## 1 Products affected

Product hierarchy no. *				Part no.	SBU	Type / Description	Customer part no.
SBU	PG	PUG	Type				
02	005	016	0000001109	See list below	Power Entry Modul w/o Filter	KE (snap-in)

Product Change Notification					PCN KE		
owner	creation date	release date	released by	change order no	rev	page	D10-039-820
huberth	20.09.2019	04.10.2019	blumhe	2018365	A	1 of 1

Old product approval / rating	New product approval / rating

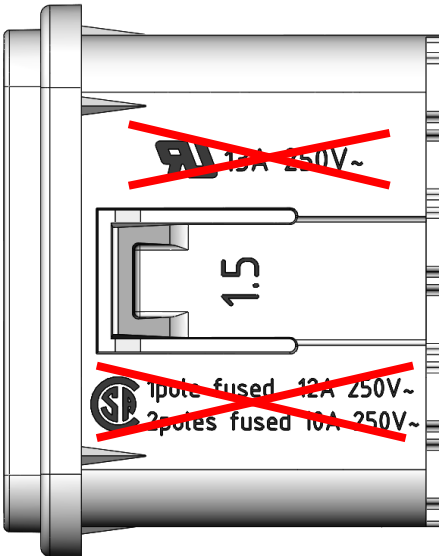
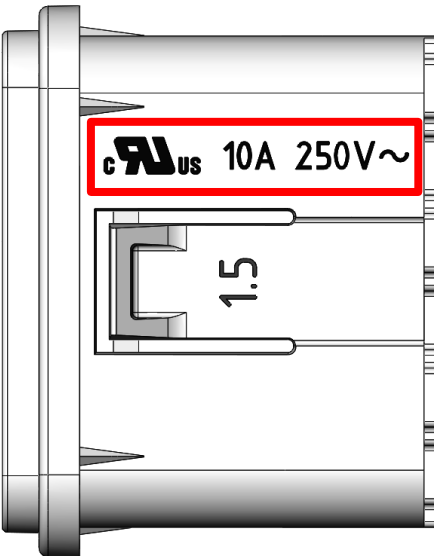
Change of approval markings from UR and CSA to the combined cURus on the product socket.

Form	Yes	Socket new with cURus approval marking (@ 10A 250VAC)
Fit	No	-
Function	No	-
Manufacturing	No	-
Label	No	-
Packaging	No	-
